# Heritage Statement Addendum

1 Montpelier Square

Project Number: 21.59  
Version: 2  
Date Issued: 12 April 2024  
Author: Joanna Burton IHBC MRTPI

Fig. 1. Approved (left hand side) and proposed (right hand side) section

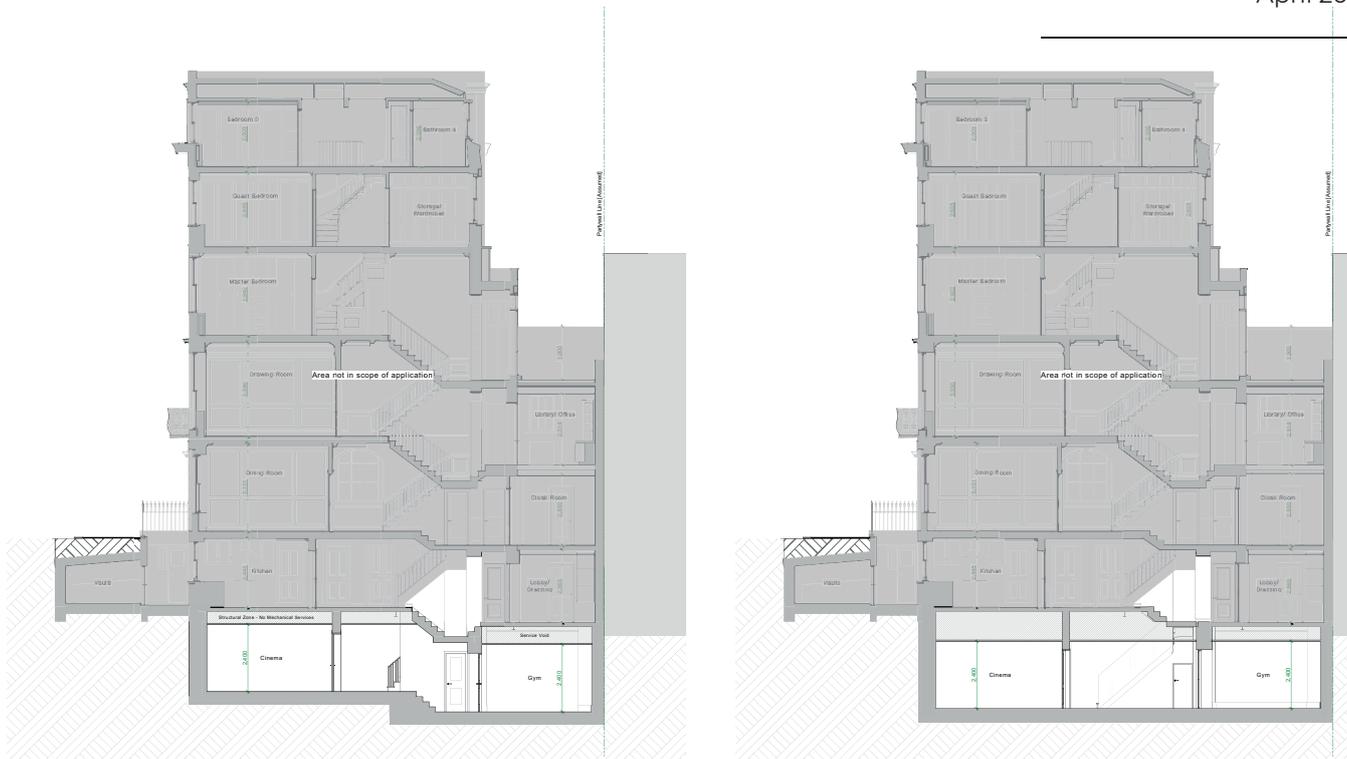
- 2.2. These steps are made necessary by the stepped profile of the floorplates through the building with the closet wing set at a lower level from the principal volume of the house. The proposal seeks to deliver a level floor plate across the basement level by increasing the floor to ceiling height in the front part of the basement to accommodate the change in levels. This increased depth would be concealed through the insertion of a dropped ceiling, creating a disguised deeper service void in the front part of the basement (Fig. 1).

- 4.2. The main change is located at basement level. Here the new stair giving access to the basement extension from the lower ground floor level will be extended and a deeper service void is proposed to be inserted above the ceiling in the front part of the building. The floor level within the front part of the building will be lowered to match the level at the rear, allowing the steps between the front and rear to be removed and thereby providing level access to the gym (Fig. 2). A dropped ceiling will be inserted to conceal the service void such that it will not be visually/appreciably apparent as part of the basement room proportions.

- 4.4. The proposed amendment reintroduces a service void using a dropped ceiling. Crucially the appreciable floor to ceiling height to all users of the building will be the height of the dropped ceiling, and not the floor plate above. For users experiencing the listed building and its significance, the floor to ceiling height proportions of the rooms within the basement level will not appreciably exceed those of the lower ground floor above. The experience of and an ability to interpret the hierarchy of the floor levels across the building will thus be sustained.

Fig. 2. Approved (left hand side) and proposed (right hand side) basement floor plan

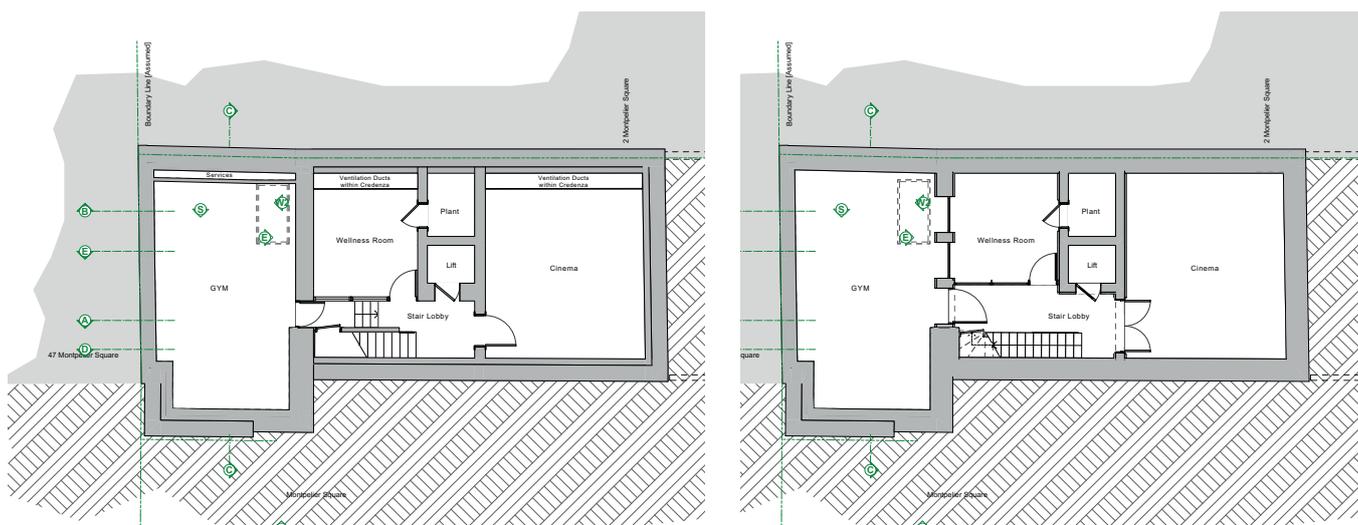
- 4.9. Other changes to the basement level are minor, including widening the doors to the cinema room and gym, and introducing two windows between the gym and wellness room to allow natural light into the latter. Given the modest nature of the changes that affect an entirely new construction these elements of the proposals will not affect the special interest of the building.
- 4.10. For the avoidance of any doubt given the internal nature of the proposed works there will be no impact on the conservation area.

Fig. 3. Approved (left hand side) and proposed (right hand side) lower ground floor plan

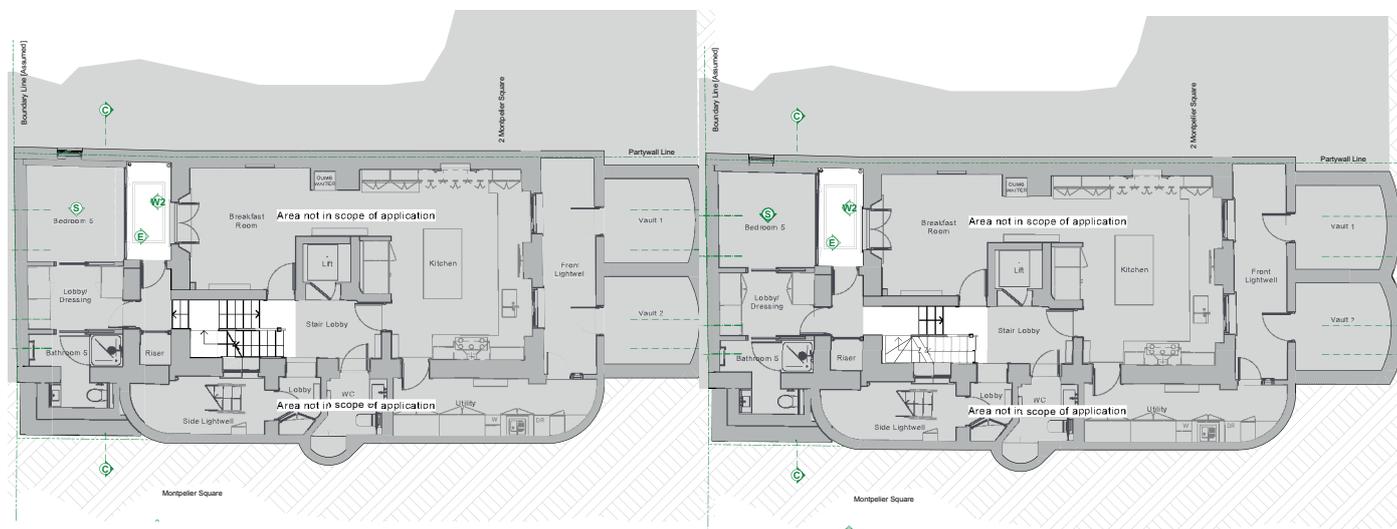
- 4.1. This proposal affects only the proposed (and approved) basement level and fabric already consented for removal. A section of the lower ground floor which does form part of the original property is shown within the proposed works (Fig. 3); this reflects the amended resolution to the change in levels between the closet wing and main volume of the building. Approval was given to lower the floor plate to the rear of the building at lower ground floor level and insert two sets of steps to navigate the level change. This has been reduced to a single set of steps replicating the arrangement above. This element of the proposal thus affects fabric already consented for alteration and will have no impact over and above what has already been consented. Arguably it will deliver betterment over the approved scheme by better reflecting the traditional arrangement as per the floors above.
